Hillingdon Flood Risk Assessment Addendum

Response to Consultee Comments

Subject	Client	Prepared by	Checked by	Issued
Hillingdon FRA Addendum	The Hillingdon Hospitals NHS Foundation Trust	Heather Wells	Matt Tandy	17 th November 2022

Figure 1 – 1 in 100 year plus 21% CC Flood Extents Option 2

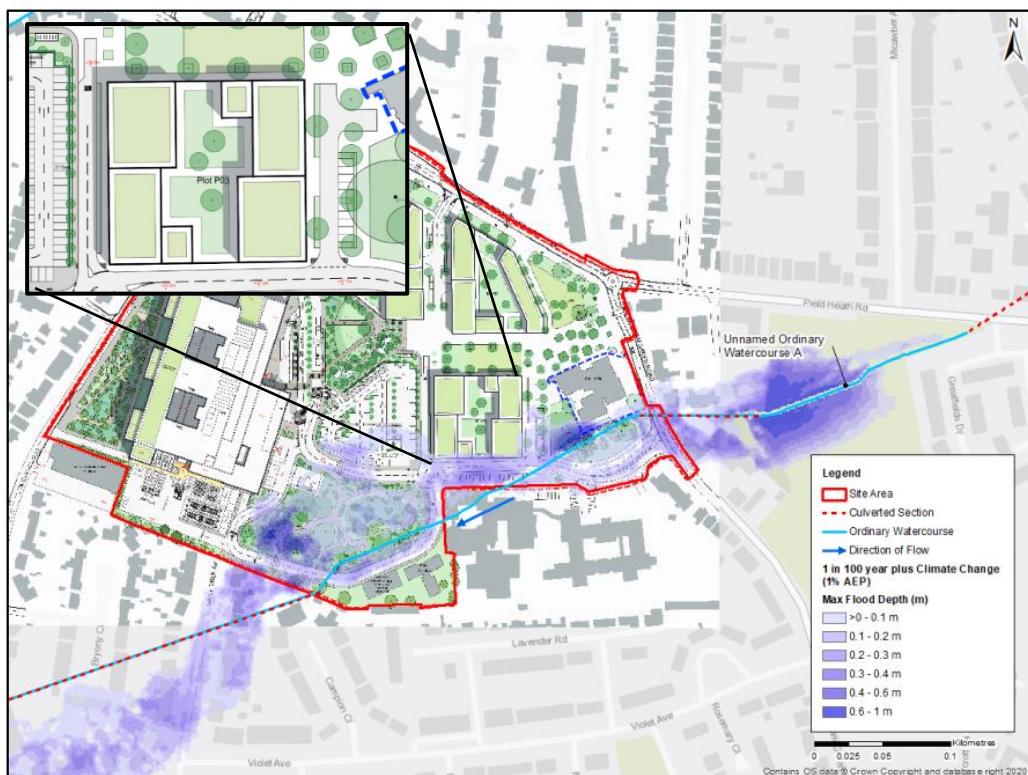
3. **Flood Risk Comment**– 'Further information / mitigation relating to the flow route into the undercroft car park should be provided'

- **Response** – A review of the hydraulic model outputs up to and including the 1 in 100 year plus 21% CC event has been undertaken to assess the fluvial flow route near the undercroft parking at Plot P03. At the time of writing the FRA, it was thought that the entrance was situated in the south-eastern corner of Plot P03, however the entrance is situated further north between two grass kerbs, as shown in **Figure 1**. The predicted fluvial flood extent in the 1 in 100 year plus 21% CC event is not shown to infringe upon the entrance of the car park. The closest flood depths at this location are predicted to remain shallow in the 1 in 100 year plus 21% CC event at approximately 0.08 m. Given the car park is proposed to be undercroft and at ground level, in the unlikely event fluvial flood extents marginally infringe upon the car park, these are unlikely to cause disruption nor damage. As the fluvial system recedes so will flood water within the undercroft carpark. Moreover, any flows will likely be captured by the proposed drainage network serving the car park. As such, it is considered that no further flood risk mitigation is required.
